**TOWN OF MOUNTAIN VILLAGE  
REGULAR DESIGN REVIEW BOARD MEETING AGENDA  
THURSDAY FEBRUARY 1, 2024, 10:00 AM  
MOUNTAIN VILLAGE TOWN HALL  
455 MOUNTAIN VILLAGE BLVD, MOUNTAIN VILLAGE, COLORADO  
TO BE HELD HYBRID THROUGH ZOOM:  
<https://us06web.zoom.us/j/86027664518>  
Meeting ID: 860 2766 4518**

**TO:** Mountain Village Design Review Board  
**FROM:** Claire Perez, Planner II  
**FOR:** Design Review Board Public Hearing; February 1, 2023  
**DATE:** January 15, 2023  
**RE:** Staff Memo – Initial Architecture and Site Review (IASR) Lot 1 Unit 1, TBD Eagle Drive.

**A1.3**

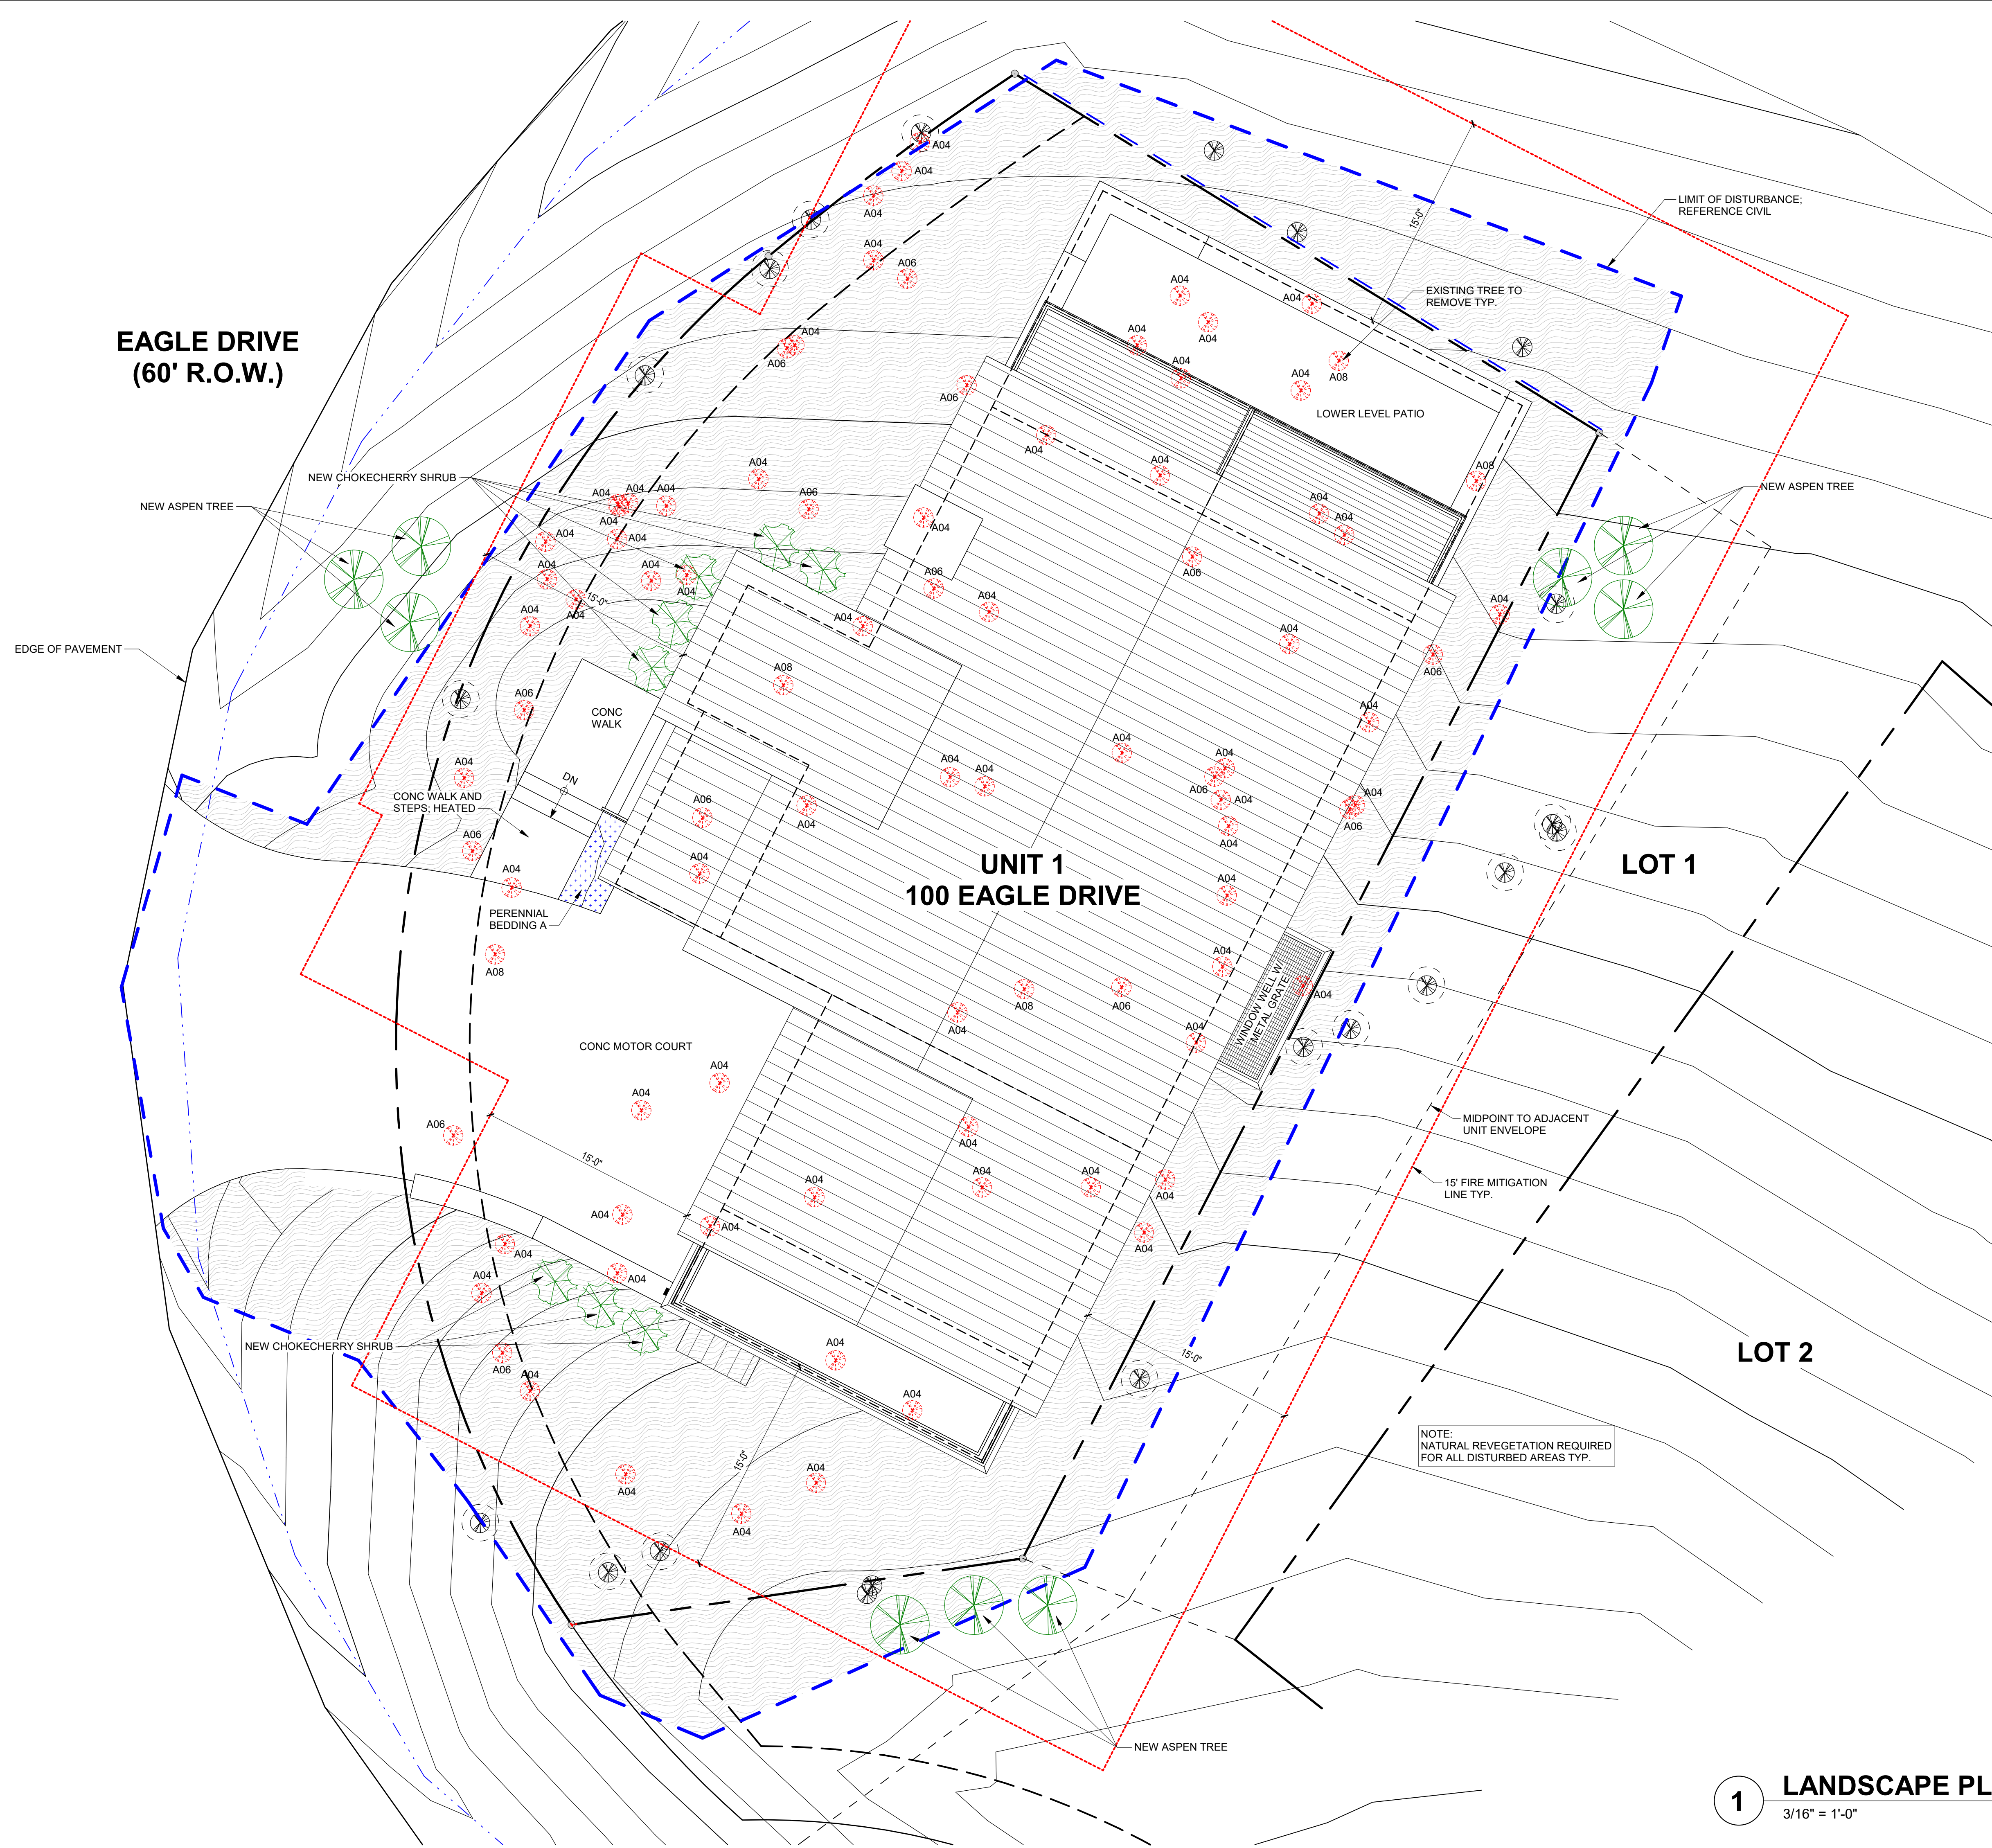
*Staff: The applicant has provided a conceptual landscaping plan. The Town Forester has reviewed the landscaping plan. Prior to Final Architecture Review, the plan should be amended per his comments.*

*TMV Forester comments: "The plan set is required to show the zone 1 wildfire mitigation boundary. No trees may remain within the zone 1 wildfire mitigation area unless CDC exceptions apply. Tree retention within the zone 1 boundary mitigation is extremely difficult due to excavation and construction activities. If trees will be retained within the zone 1 fire mitigation area, they must be approved by the Town Forester and a more durable tree protection fencing system must be installed in order to ensure they will not be damaged during construction.*

- 1) Prior to final review, the applicant shall modify the landscaping plan to adhere to the CDC and the Forester's comments.
- 2) Prior to the issuance of a building permit, the town forester shall sign off on both the landscaping plan and fire mitigation plan.
